DART SERVICE INSTRUCTION

TO AMEND INSTALLATION INSTRUCTIONS IIN-D412-698 REV. E & INSTRUCTIONS FOR
CONTINUED AIRWORTHINESS ICA-D412-698 REV. 5
REF. TCCA STC SH92-43
REF. FAA STC SR01446NY
REF. EASA STC EASA.IM.R.S.00709

1.0 PURPOSE

The purpose of this service instruction is to add the D412-698-111/-112 Cabin Door Roller kits for installation on aircraft equipped with cargo door assembly P/N's 205-031-669-15 (LH) and 205-031-669-16 (RH). Customers who have purchased the D412-698-011/-012 kits can upgrade to D412-698-111/-112 using the DSI 9635-011/-012 kits as follows:

FIGURE 1 – INSTALLATION OVERVIEW

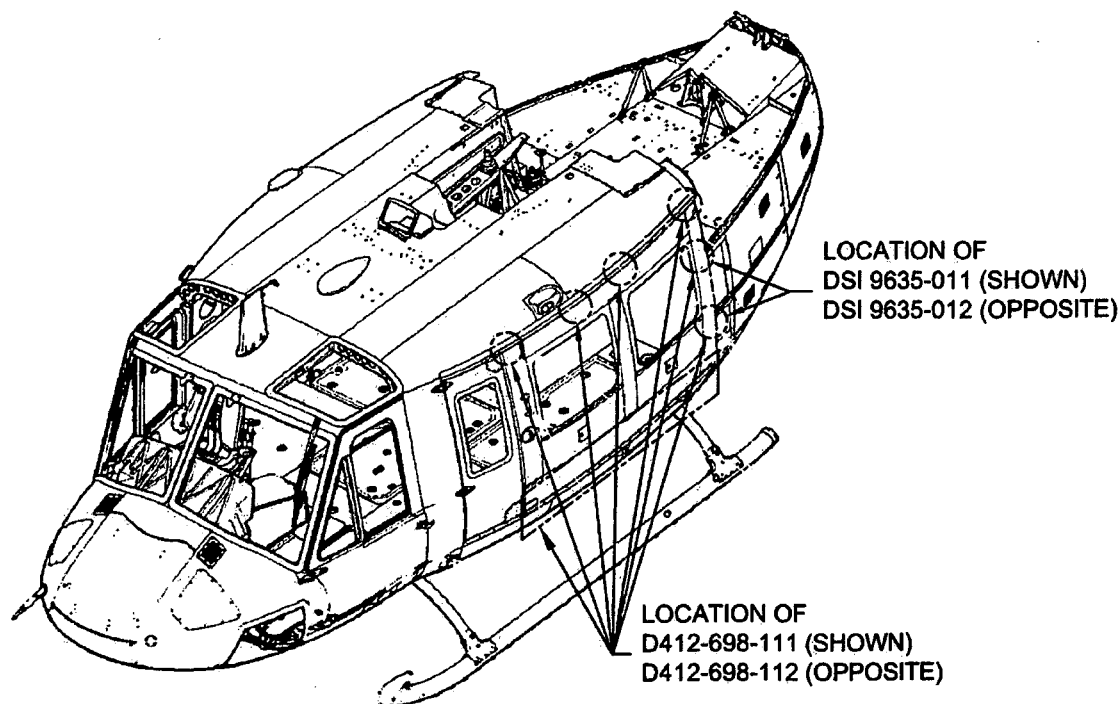
- 3.1 Remove LH and/or RH sliding doors (ref P/N 205-031-669-15/-16) from the aircraft per the Aircraft Maintenance Manual.
- 3.2 Remove 205-031-436-001 and replace with D3121-141 Bracket (3 places). Reuse existing hardware and shims if determined to be airworthy. Alternatively, if using D412-698-021 Replacement Shim Kit, install D3238-1 & D3238-11 as required. Note that the D3121-141 brackets contain one additional middle slot not used for this installation (see Figure 6 of IIN-D412-698 or Figure 52-8 of ICA-D412-698).

- 3.3 Remove 205-031-435-001/002 and replace with D3121-143 Bracket for left hand doors and D3121-144 Bracket for right hand doors. Reuse existing mounting hardware and shims if determined to be airworthy. Alternatively, if using D412-698-021 Replacement Shim Kit, install D3238-3 & D3238-13 as required. Note that the D3121-143/-144 brackets contain one additional middle slot not used for this installation (see Figure 6 of IIN-D412-698 or Figure 52-8 of ICA-D412-698).

- 3.4 Remove 205-031-433-1 Roller Support (LH) and 205-031-433-2 Roller Support (RH) and replace with D4737-043 on left hand doors and D4737-044 on right hand doors. Reuse existing mounting hardware and shims if determined to be airworthy. Alternatively, if using D412-698-021 Replacement Shim Kit, install D3238-5 & D3238-15 as required.

- 3.5 Remove 205-031-434-1 Roller Support and replace with D4737-041. Reuse existing mounting hardware and shims if determined to be airworthy. Alternatively, if using D412-698-021 Replacement Shim Kit, install D3238-5 & D3238-15 as required.

FIGURE 2 - MODIFIED SLIDING DOOR
(D412-698-111 SHOWN, D412-698-112 OPPOSITE)

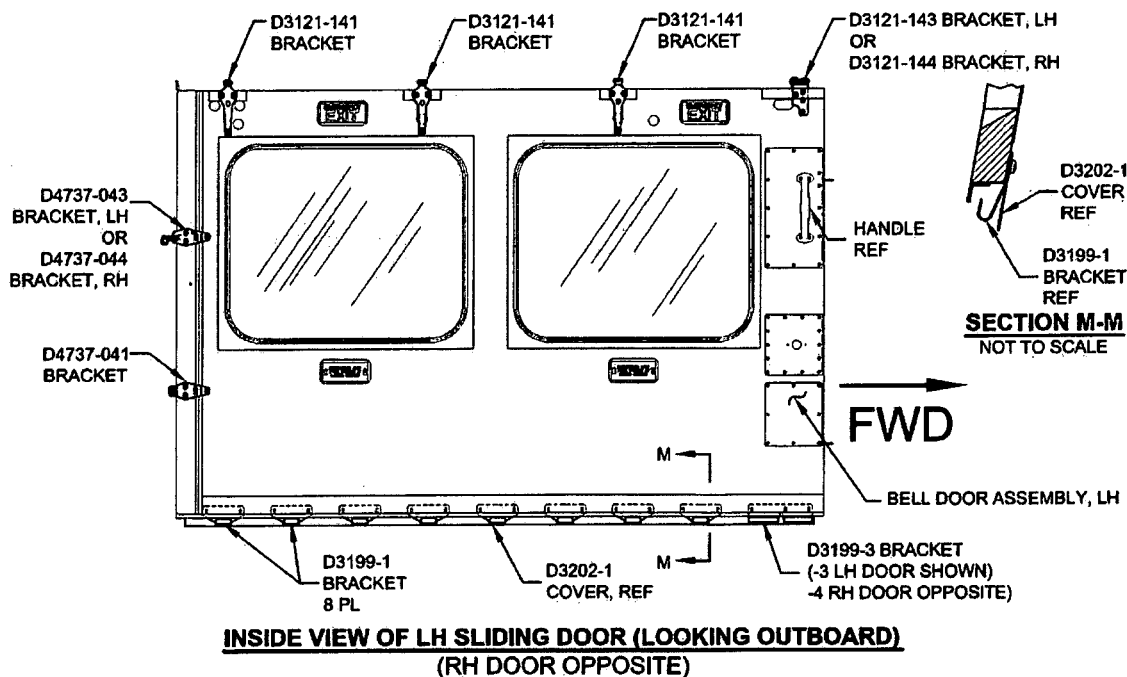
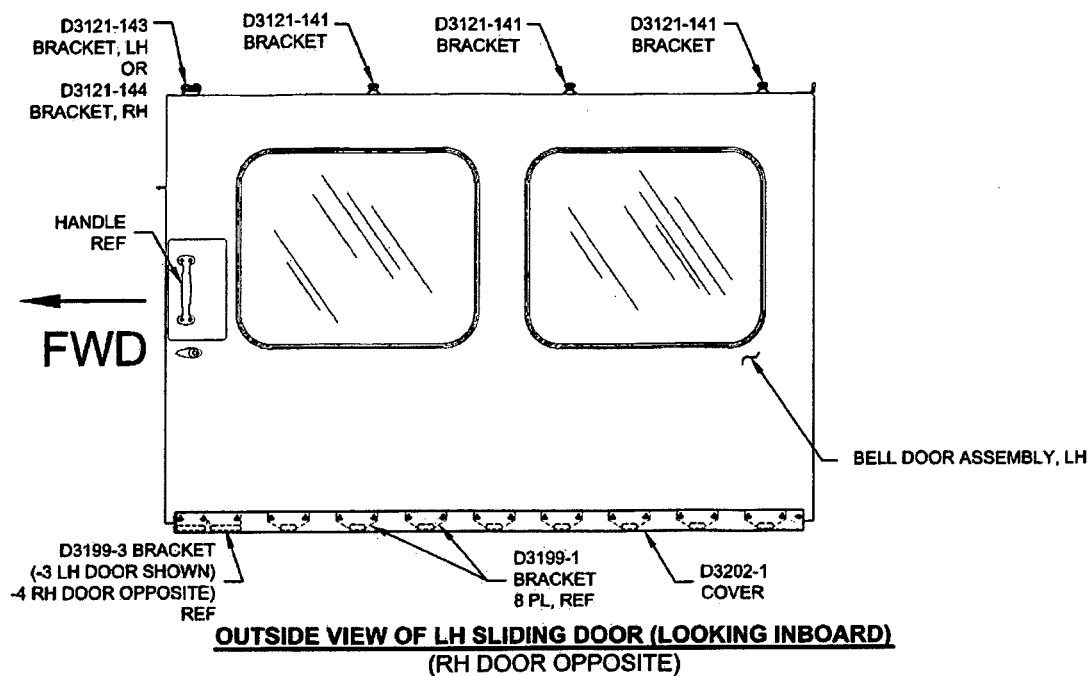
- 3.6 Remove 205-032-669-125 Track (LH) and/or 205-032-669-126 Track (RH) as applicable. Install D3199-1/-3/-4 Brackets and D3202-1 Cover as shown in Figure 2 using existing mounting hardware if determined to be airworthy.
